**GROWTH MANAGEMENT DEPARTMENT STAFF REPORT**  
**PONTE VEDRA OVERLAY DISTRICT**  
**April 26, 2023 Public Meeting**  
**ARC 2023-04 GATE @ Shoppes of Ponte Vedra Tennis Facility**

**To:** Architectural Review Committee  
**Staff:** Sloane Stephens, Planner  
**Date:** April 11, 2023

**Summary of Request:** Applicant is requesting design approval for the construction of 12 lighted tennis courts and associated facilities that will include a clubhouse, restroom, maintenance shed, and a perimeter fence 6 feet in height along the south and west property boundaries. All relevant application materials are attached to this Staff Report.

LIGHTING PROPOSAL LD-157626  
SHOPPES OF PONTE VEDRA-TENNIS/LDT  
STATE RD A-1-A NORTH  
ST. JOHNS, FL

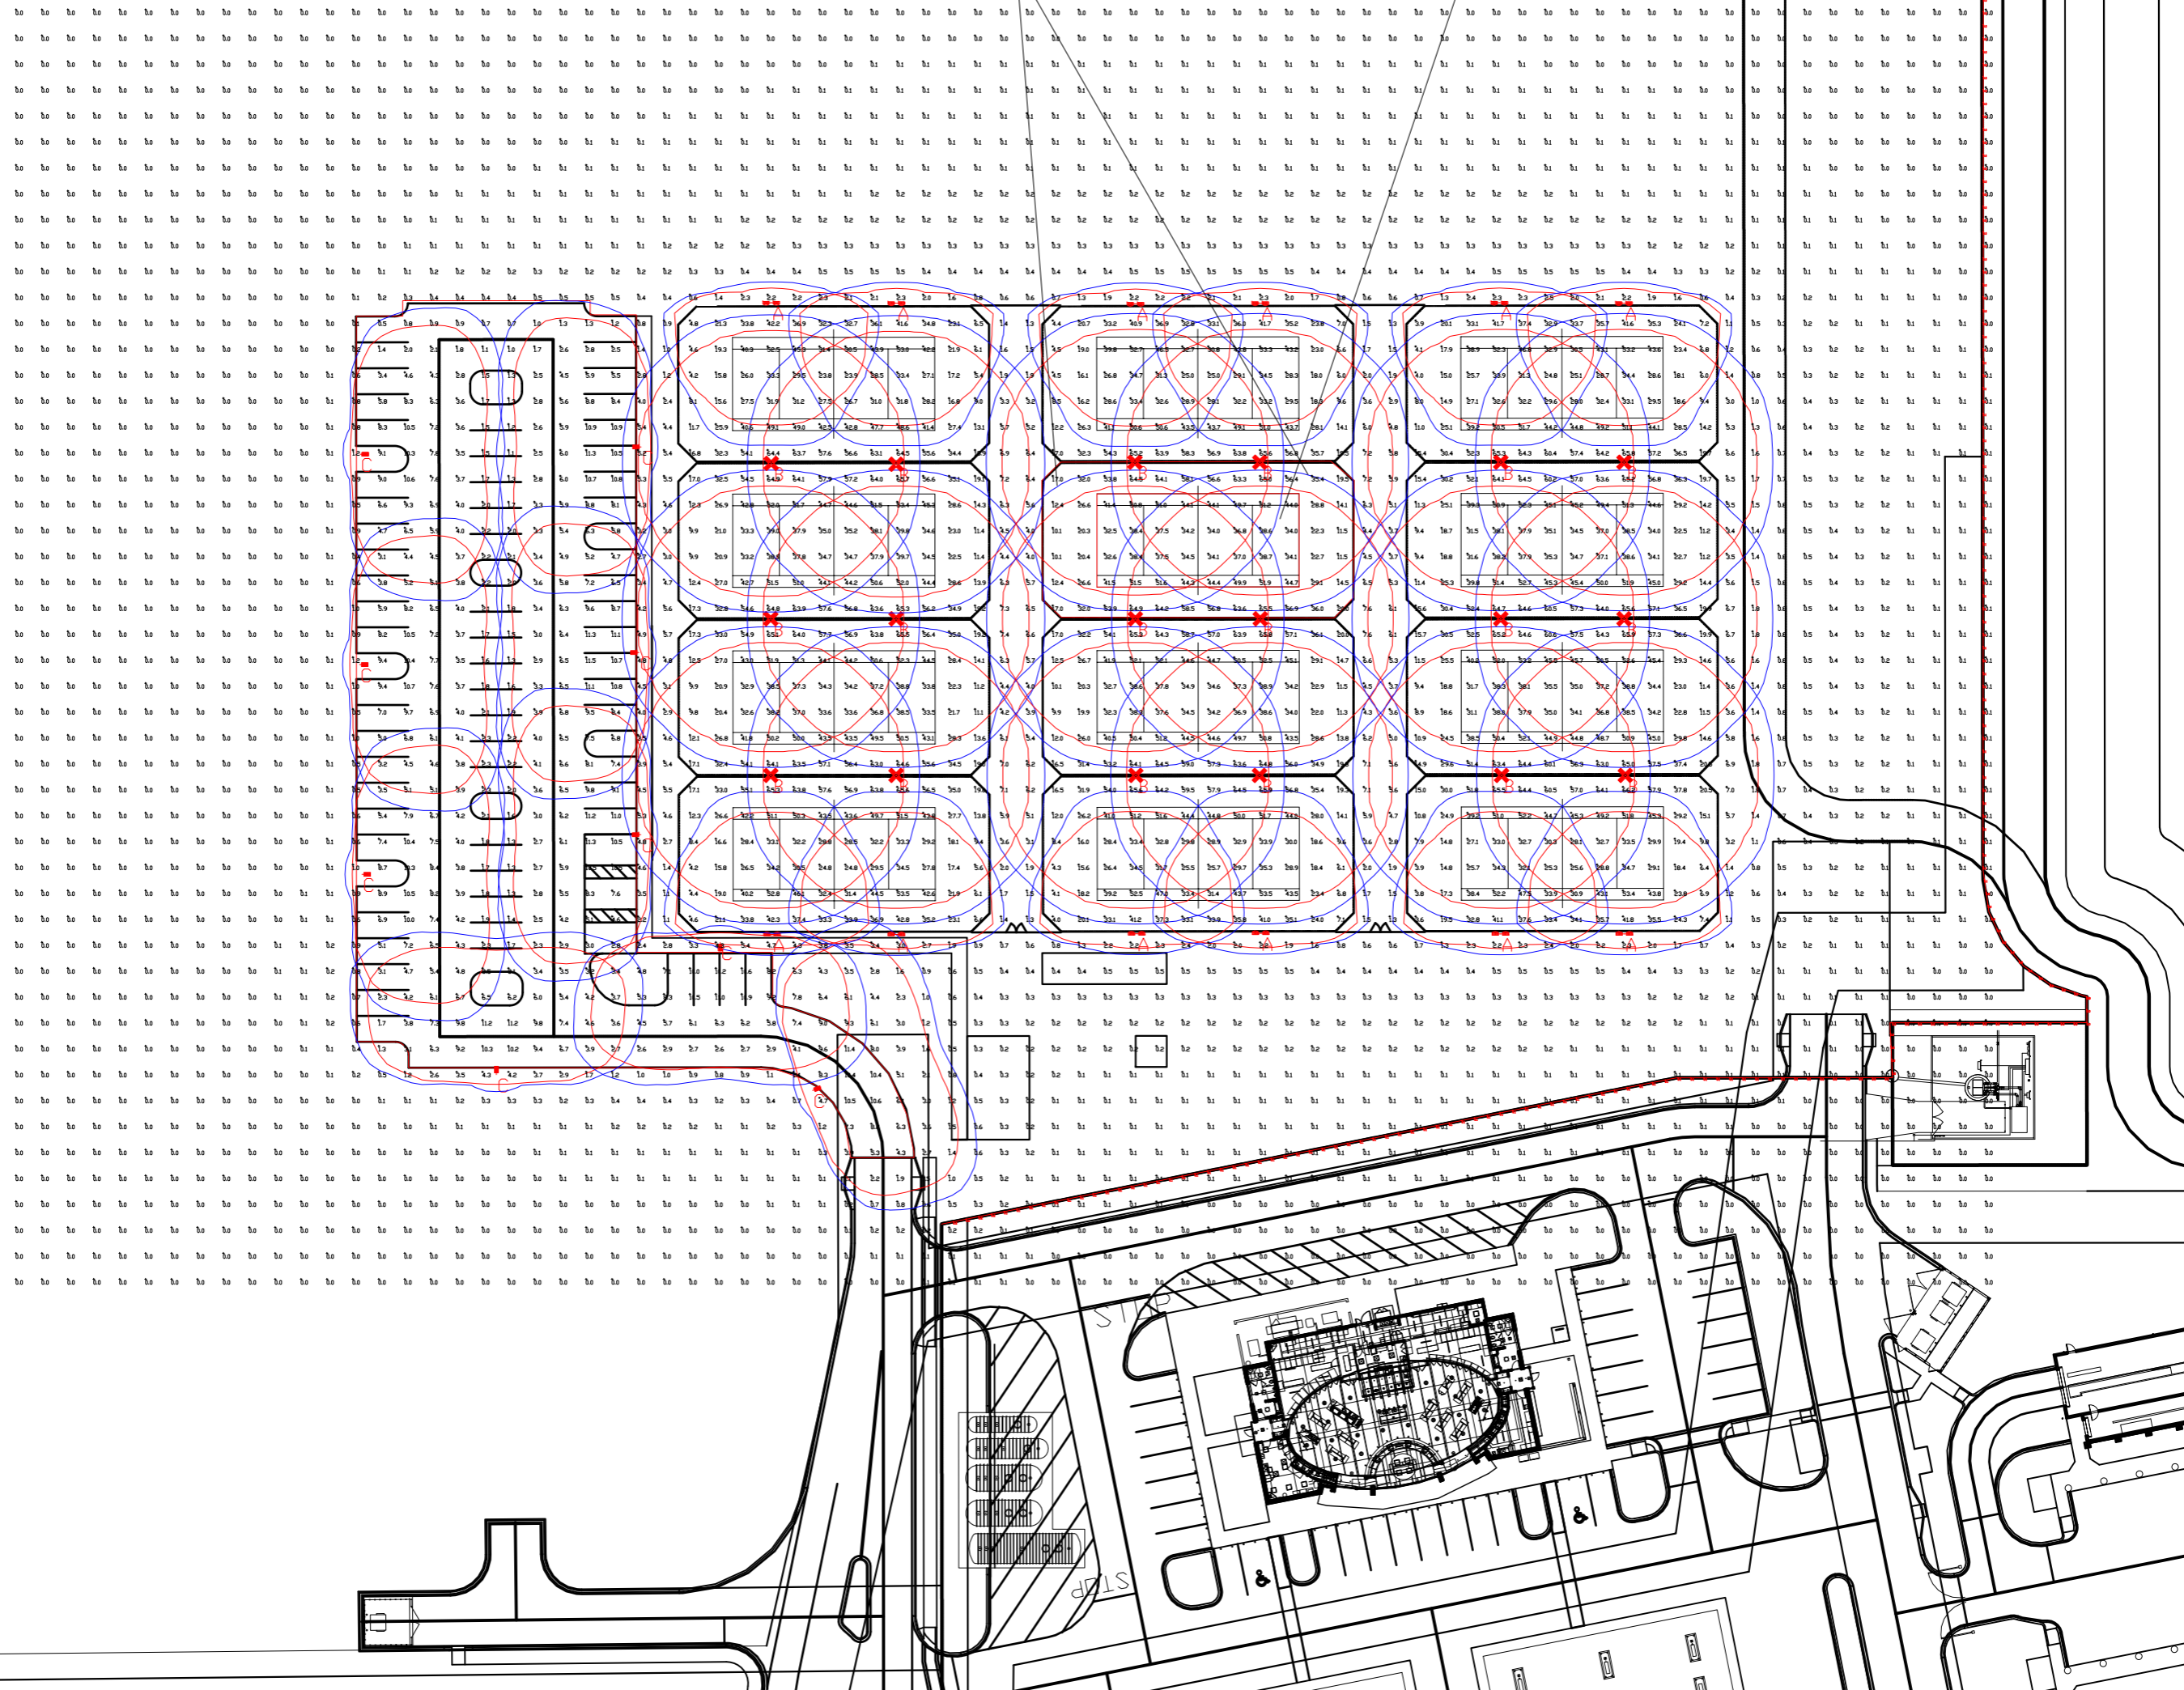
Per PVZDR Section VIII.Q.5.a(8), exterior lighting for safety and security shall be kept to a minimum, and security lights shall not be visible from adjacent residential properties. According to the photometric plan, the lighting from the parking lot and tennis courts is 0 footcandles at the lot line. The closest detection of light is 0.1 footcandles at 178' from the northern lot line.

Tennis Fence Perspective from A1A

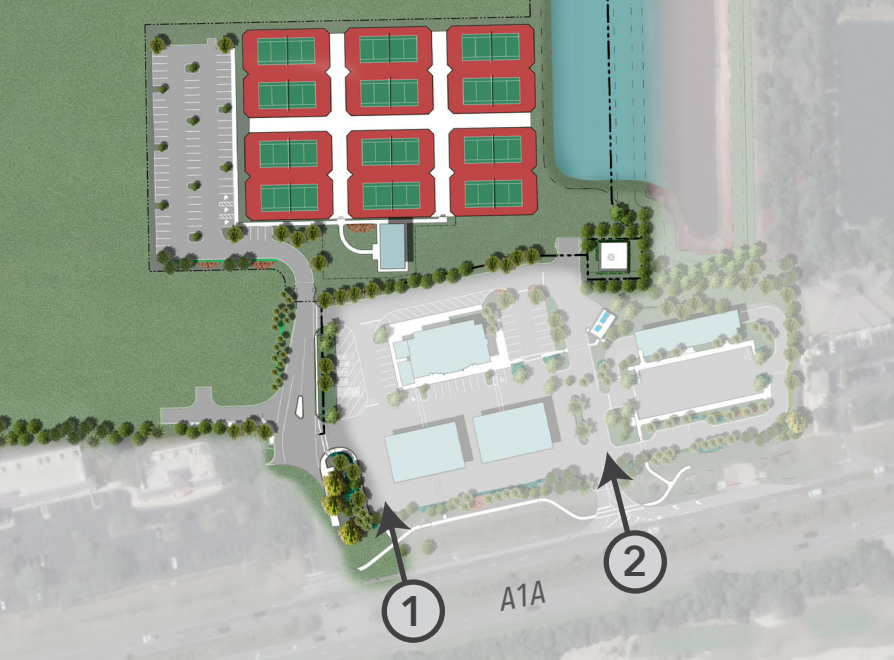
Per PVZDR Section VIII.Q.5.a(7), chain link fencing shall not be permitted where it can be viewed from any roadway. The Applicant has provided the following information to support that the tennis fencing complies with this section:

*We believe the tennis fence will not be visible from A1A for a couple of reasons. First, the tennis fencing with black windscreen is approximately 465' away from the ROW at its closest point. Additionally, the posted speed of A1A is 45mph, so the vehicles will be driving at a rate of speed and with hard viewing angles which will prevent the driver to see the fence. Finally, there is an intense amount of landscape which blocks the views of the tennis courts. This buffer is provided by both the recently constructed commercial development as well as the existing retail buildings. Hence the only possible view of the tennis fence would be once a vehicle enters the site.*

The Applicant has been recommended to be prepared to provide additional buffering/screening.
